Powerhouse Parramatta SSSA Reflectivity Response to Submissions

This letter is in response to submissions raised as part of the public exhibition of the Powerhouse Parramatta State Significant Development Application relevant to the Reflectivity Report, PHM-ARP-REP-FA-0003 (Arup, April 2020).

Figure 1: Map of ferry's travel path showing turning circle where east facades cast solar reflections above 500 Cd/m²

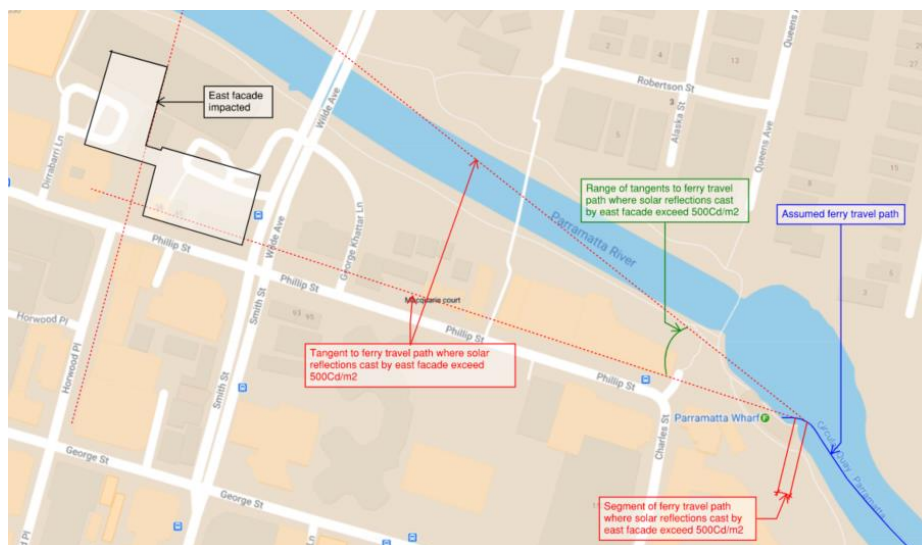
Provide further analysis and mitigation options for any reflectivity impacts on ferry operations.

The ferry approach on Paramatta River (Figure 1) has been reviewed for reflectivity impacts on ferry operators using the analysis method as for road traffic. Due to the limited exposure, the Reflectivity Report PHM-ARP-REP-FA-0003 noted that reflections are not expected to result in unacceptable glare towards ferry operators in this location. The below records additional considerations of mitigating factors and extent of reflection exposure to provide further context.

Viewed from the river, the east facades can potentially briefly cast solar reflections above the 500 Cd/m² threshold towards ferry operators (Figure 1). This only occurs at the ferry's turning circle, i.e. when the ferry turns to dock at the wharf (Figure 2). For the ferry travel path assumed, this is an approximately 8m stretch of the ferry's travel path (Figure 1). For the majority of the ferry's travel parallel to the river, the reflectance is below the 500 Cd/m² threshold (Figure 3).
